Report: E-14-029

## Region of Waterloo

**Subject:** **River Road Extension, King Street to Manitou Drive, Kitchener, Class Environmental Assessment – Recommended Design Concept**

# Additional Interchange Concepts resulting from May 17, 2011 Public Consultation Centre

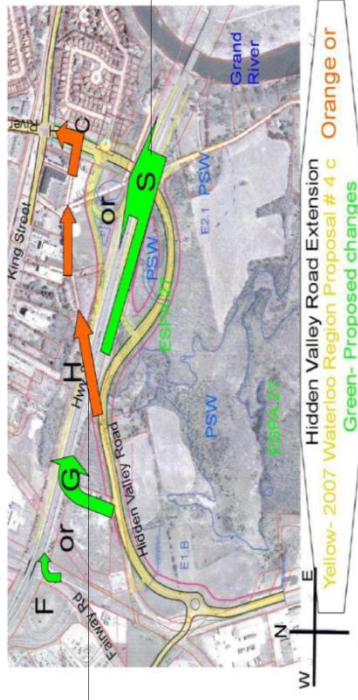
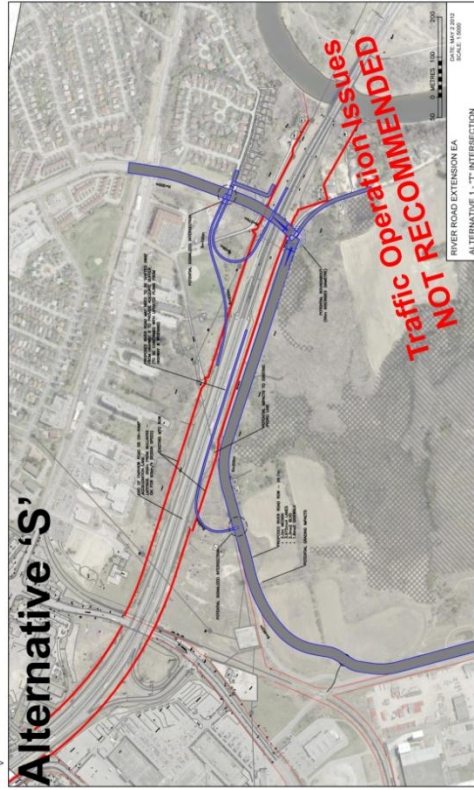
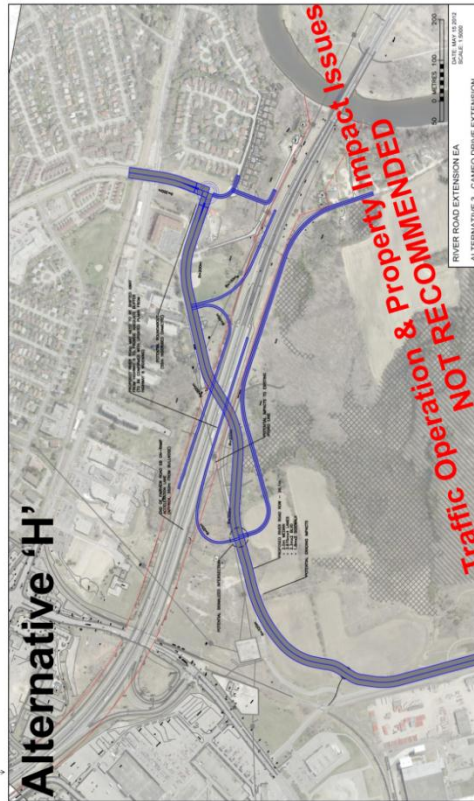
**Unacceptable Operational Issues:**  
Having these tight turns on a River Road Extension could have the following adverse impacts :

- mislead driver expectations;
- cause vehicle control problems at higher speeds , especially under wet/snowy weather conditions; and
- increase the potential for more collisions, particularly rear-ends.

APPENDIX I-4

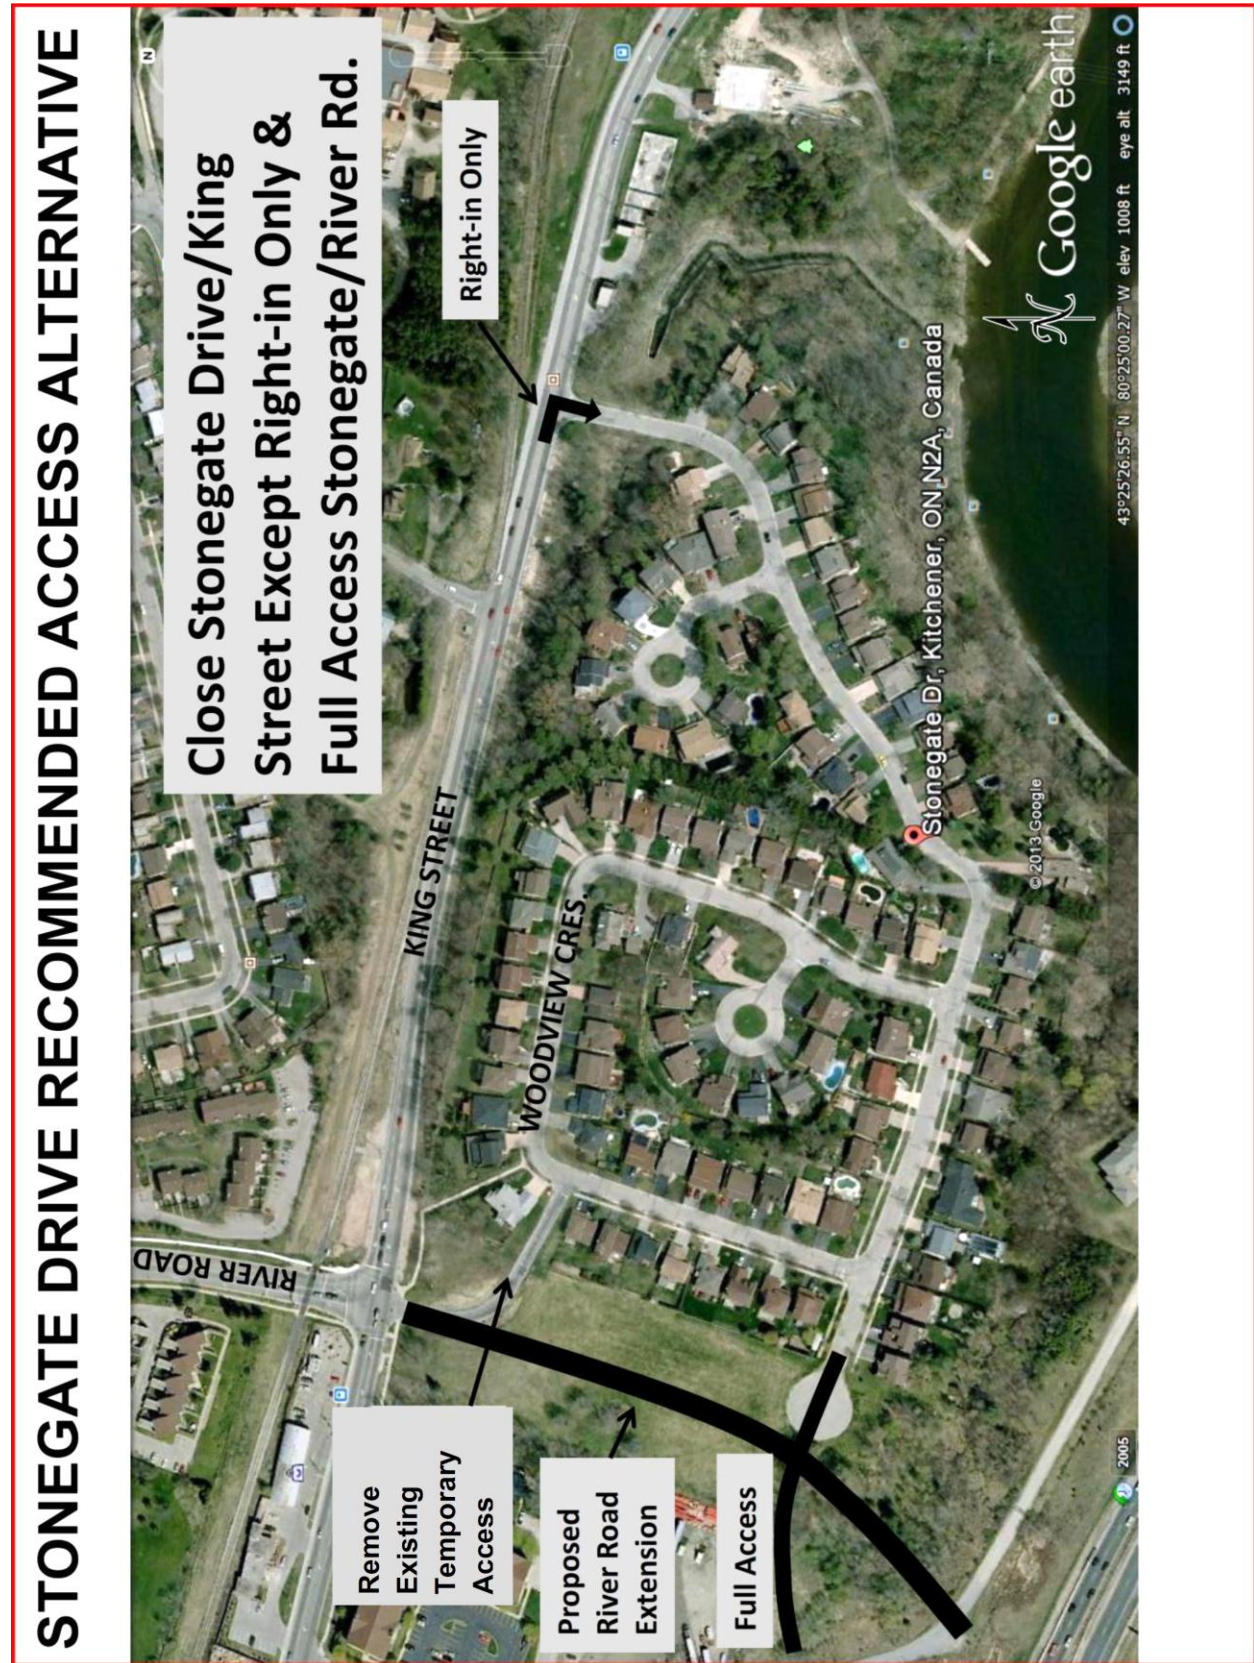
5 of the 12 delegations that addressed Regional Council at the PIM voiced concern with the preferred design for access to Stonegate Drive. The concerns expressed included:

- Full access should be provided at the River Road Extension/Hwy 8 ramp intersection, for the convenience of residents. If this results in any increase in collisions or infiltration of commuter traffic through the neighbourhood, further assessment of the operation may lead to corrective measures;
- Vehicles will shortcut from King Street, west-bound via Stonegate Drive to the Highway-8 on-ramp increasing traffic on Stonegate Drive;
- Increased use of the Intersection at King Street/Stonegate Drive to access the neighbourhood is undesirable because the King Street end of Stonegate Drive is poorly suited to any increase in traffic volume; and
- Access to Stonegate Drive at the River Road Extension/Hwy 8 ramp intersection should be restricted to emergency vehicles and only used for right-turn out.

Subsequently, on December 10, 2013, the City of Kitchener held a neighbourhood meeting for the Stonegate residents to discuss concerns with the design for access to Stonegate Drive. The meeting was hosted by two of the City representatives on the Project Team and was well attended. At the meeting, City representatives heard concerns similar to the ones expressed at the PIM and received suggestions to consider design concepts to reduce access to Stonegate Drive from the existing intersection at King Street.

All Stonegate Drive neighbourhood access alternatives considered to date are summarized in Appendix I. The Project Team reviewed the input received at the PIM and by the City of Kitchener at the neighbourhood meeting December 10, 2013 including all the alternative access alternatives suggested to date. The Project Team has concluded that an additional alternative will best ensure an elimination of “cut-through” traffic while ensuring that a high level of access by local traffic and an alternate emergency access route will also be provided. That alternative is described as follows:

- Close Stonegate Drive at King Street except for Right-turn Entry and allow full movements at River Road and Stonegate Drive - This concept would allow all movements into and out of Stonegate Drive at River Road and Highway 8 on and off-ramps, as shown in Appendix “I-3”. The intersection of Stonegate Drive and King Street would be closed except to allow local traffic to enter making a right-turn from King Street and to allow entry and exit by emergency vehicles. This is supported by the Project Team as the Recommended Design Concept.

A tabular summary of the technical evaluation of all access alternatives for Stonegate Drive access is presented in Appendix “I”. The Project Team has selected the “Close Stonegate Drive at King Street Except for Right-turn Entry and full movements at the River Road and Stonegate Drive neighbourhood” option as the recommended option because it represents the best balance of competing needs. Although it does not completely satisfy the desire of some neighbourhood residents for an unimpeded access to/from King Street, it does provide adequate emergency access to the neighbourhood while eliminating traffic infiltration on to Stonegate Drive. In selecting this option as the Recommended Design option, the Project Team is acknowledging the greater good of eliminating “cut-through” traffic when compared to the convenience of easy access to/from King Street. City of Kitchener Operations and Fire Department and Regional Emergency Medical Services were consulted and all confirmed that the design is acceptable. Liaison with those three groups will be required to finalize a detailed design for the King Street/Stonegate Drive intersection. MTO has confirmed that the recommended option will be permitted.

## Design Changes Presented by a Land Owner, Delegation at the Public Input Meeting (PIM), December 3, 2013

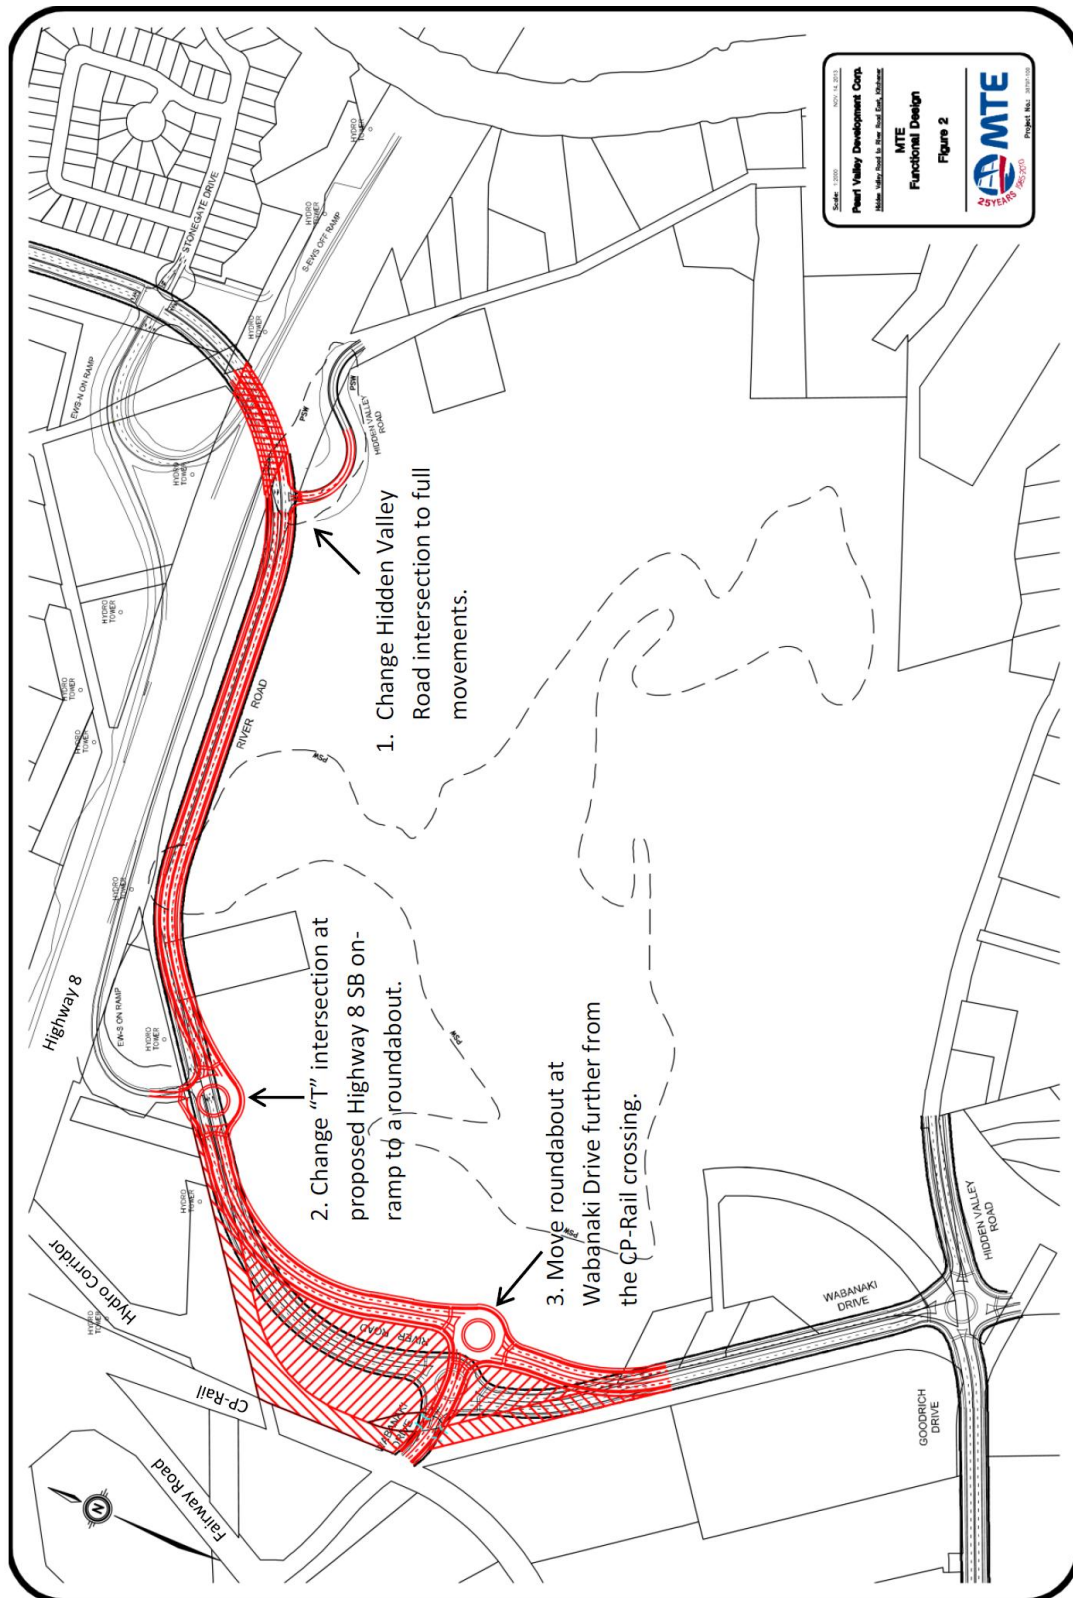
Mr. Peter Benninger is the owner of Pearl Valley Developments (PVD) which owns almost all of the undeveloped land in the Hidden Valley Area. A significant portion of that land will be required for construction of the Recommended Design Concept. Mr. Benninger appeared as a delegation and proposed two changes in the Preferred Design Concept as shown in Appendix J and described as follows:

1. Design the River Road/Hidden Valley Road intersection to permit full movement entry and exit instead of right-in and right-out as per the current Preferred Design Concept. If that is not possible, a roundabout or permitted U-turn at the new Highway 8 south-bound on-ramp is requested to reduce the distance by 460m for a west-bound vehicle to make a U-turn and then return to access the Hidden Valley Drive intersection.
2. Move the proposed roundabout at Wabanaki Drive further from the CP-Rail crossing.

Project staff have met with Mr. Benninger on two occasions to discuss the proposed changes. The Project Team evaluated the merits of the proposed changes based on the benefits for the Study area, with no consideration of access to future development on PVD land which have not been submitted to the City of Kitchener for approval. Such approval would be contingent upon PVD's compliance with the Official Plan, zoning, traffic impact study and environmental impact study requirements. During detail design, staff will work with PVD to assess the merits of minor changes to the road and intersection designs as PVD progresses through the land development process.

1. Conversion of the River Road/Hidden Valley Drive intersection to a full movement intersection was previously supported by some members of the public but was opposed by 3 other delegations at the PIM. The intersection is located in the middle of a tight banked curve within the highway interchange area. The sight distance in both directions is insufficient for left turns, even when improved by a widening of the Highway 8 bridge to provide an extra turn lane and would be expected to result in collisions due to left-turning vehicles being overtaken by vehicles approaching from the rear. Therefore, this change is not recommended by the Project Team.

While a roundabout at the new Highway 8 south-bound on-ramp would provide a small reduction in distance for traffic heading west to make a U-turn at the roundabout at the new Hwy 8 south-bound on-ramp versus the Wabanaki Drive roundabout, it would result in delays and collisions. The sight distance in both directions would be insufficient for U-turns at the Highway 8 south-bound on-ramp. Therefore, these two changes are not recommended by the Project Team. The Project Team has advised Mr. Benninger that in future if a development plan is approved that would justify a roundabout or if during detailed design, the requirements for a permitted U-turn can be satisfied, those changes will be considered, subject to MTO approval.

2. Shifting the proposed Wabanaki Drive roundabout would provide increased separation and storage for vehicles between the roundabout and the CP-Rail crossing and could potentially reduce the net impact on the lands remaining for development after the Region acquires property for the recommended corridor alignment. The Project Team recommends that this change be evaluated during

the detailed design, in discussion with the property owner to address concerns with the design, noting that the roundabout location is subject to approval by MTO because of its close proximity to the Highway-8 on-ramp.
